Yuma County Department of Engineering

TO: All Known Contractors, Plan Holders, & Other Interested Parties
FROM: Dave Wostenberg, P.E., Project Manager
SUBJECT: Addendum No. 1
PROJECT: Avenue A & County 15th St, CIP 1.9915E
DATE: August 20, 2020

Project: County 15th St - Avenue A Intersection Improvement Project, CIP No. 1.9915E

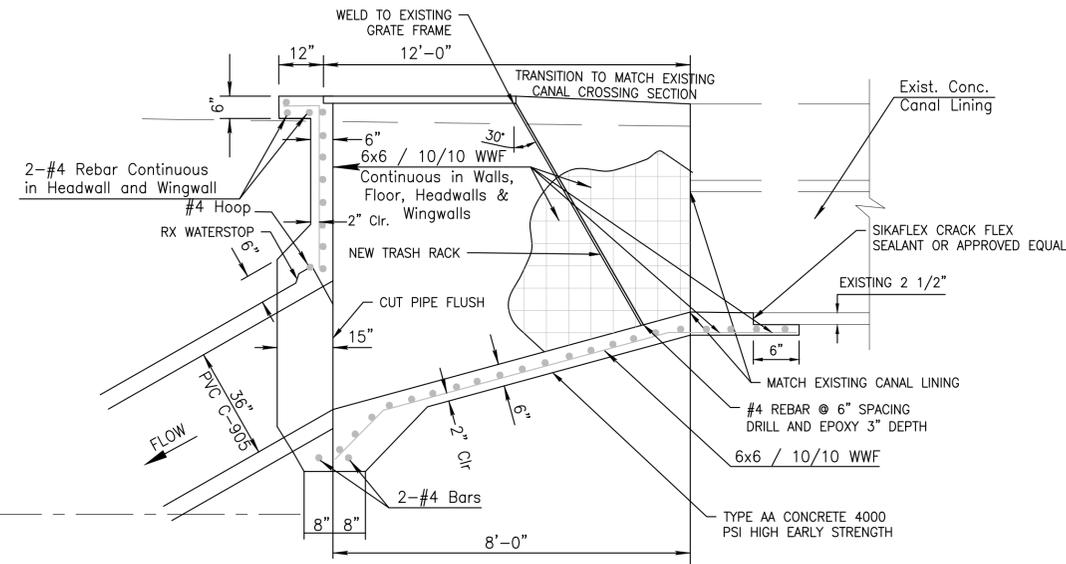
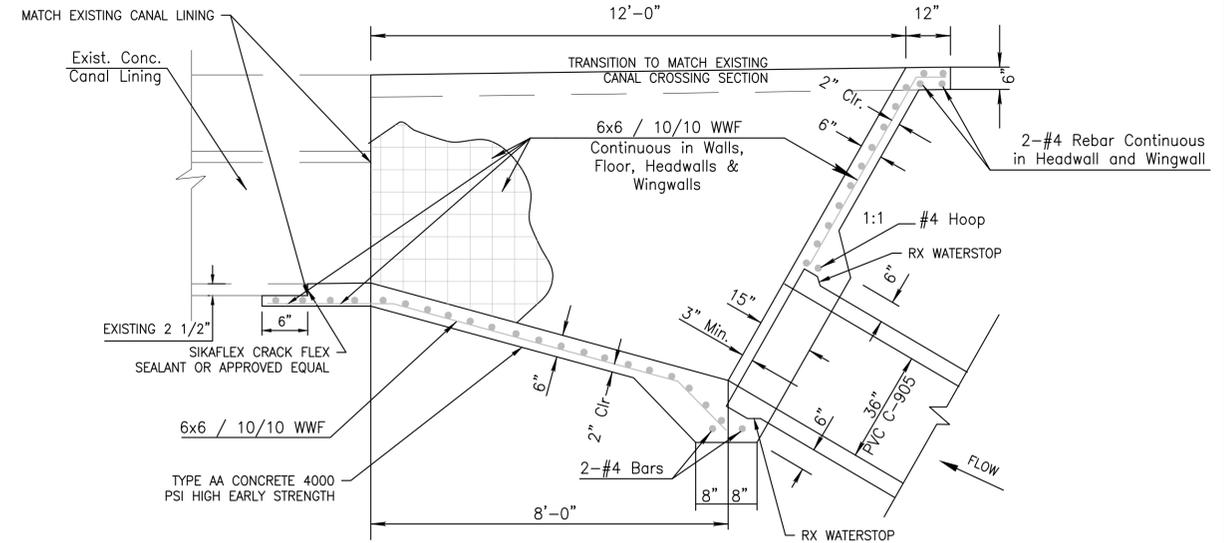
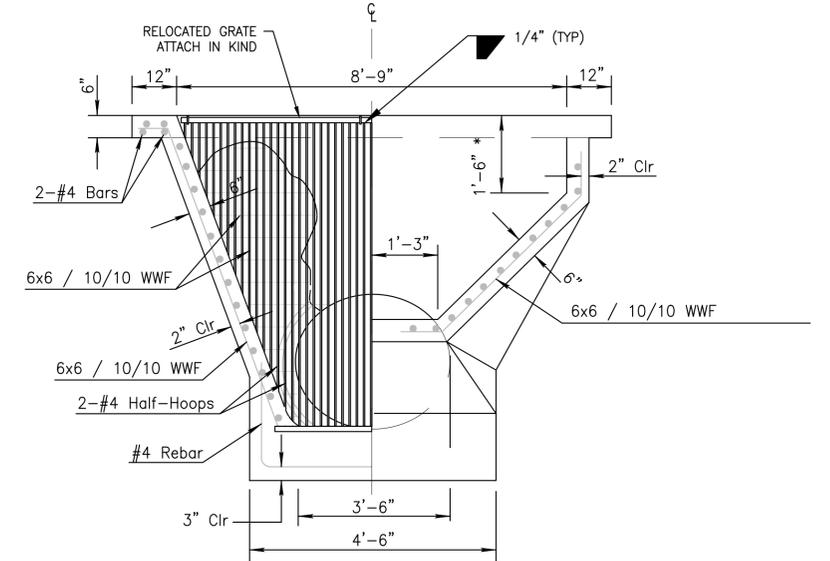
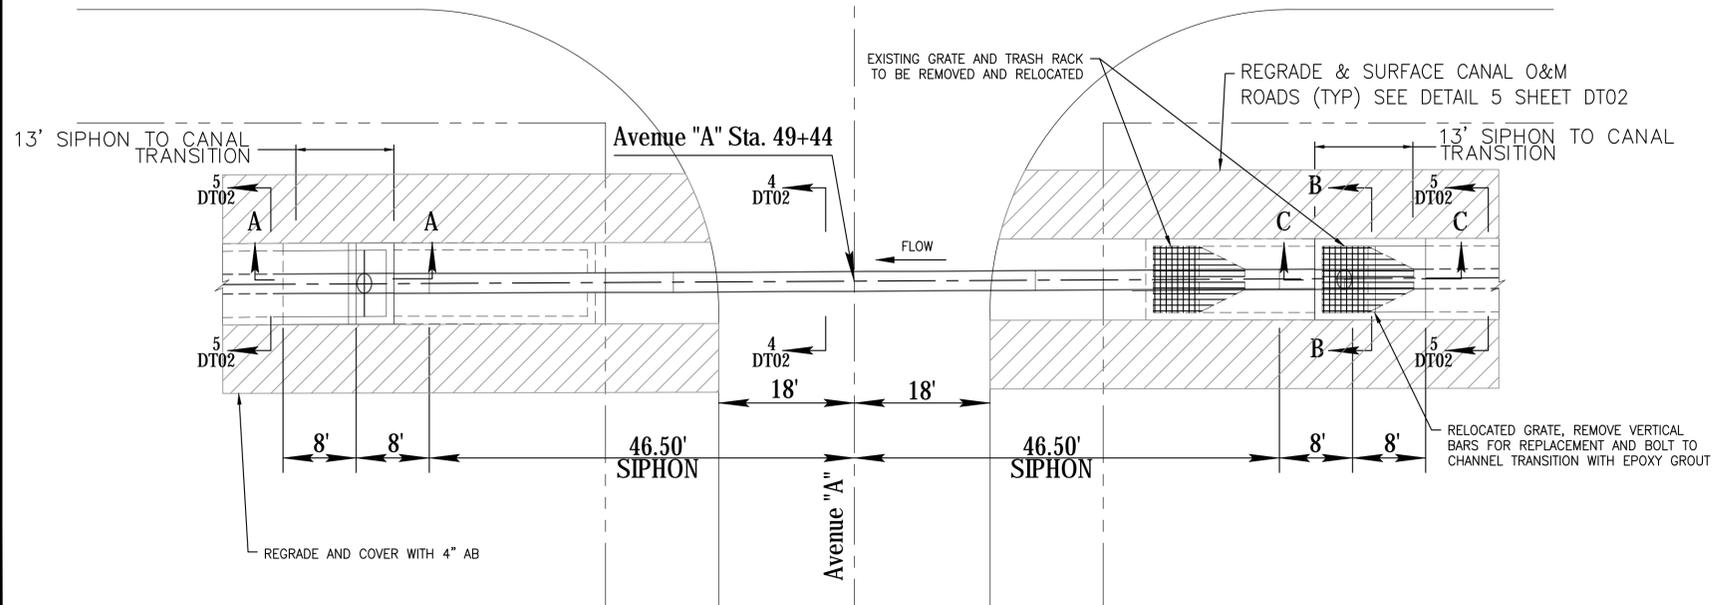
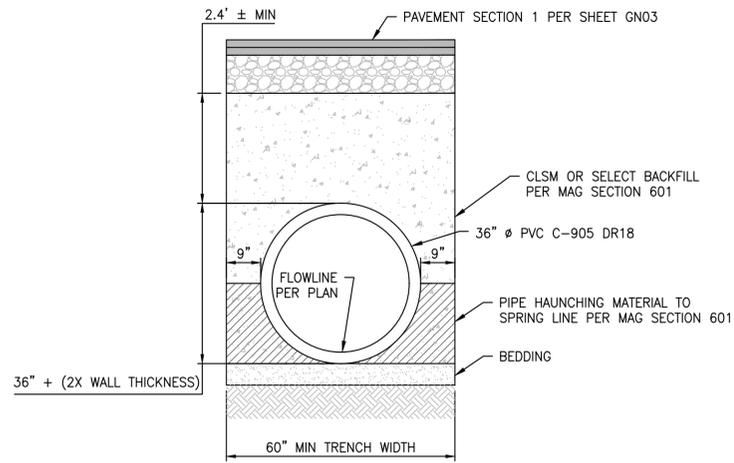
Additional siphon and canal details added to plans. Structural backfill shall be considered incidental to siphon replacement. Sheet 24 has been revised and Sheet 24A has been added. Remove Sheet 24 from your Plan Set and insert Addendum #1 Plan revisions and be guided accordingly.

Contact Arizona 811 at least two full working days before you begin excavation. ARIZONA 811 Call 811 or click Arizona811.com	
08/17/2020	SIPHONE BEND ANGLE REVISED
DATE	DESCRIPTION
APPROVED	
RICK ENGINEERING COMPANY 6150 NORTH 16TH STREET PHOENIX, AZ 85016 602.957.3350 <small>Tucson - San Diego - Riverside - Orange - Sacramento - San Luis Obispo - Denver</small> <small>rickengineering.com</small>	
YUMA COUNTY DEPARTMENT OF ENGINEERING STATE OF ARIZONA COUNTY 15TH STREET - AVENUE A INTERSECTION IMPROVEMENT PROJECT SECTIONS SW 28, SE 29, NE 32 & NW 33	
DETAILS	
DATE: 07-14-2020	
DESIGN: SP	
DRAWN: MG	
CHECKED: SP	HORIZ SCALE: 1"=20'
RICK PROJ. No. 5069	VERT SCALE:
PURCHASE ORDER 150552	DT01
YUMA CO CIP NO. 1.9915-E	SHEET 24 OF 30
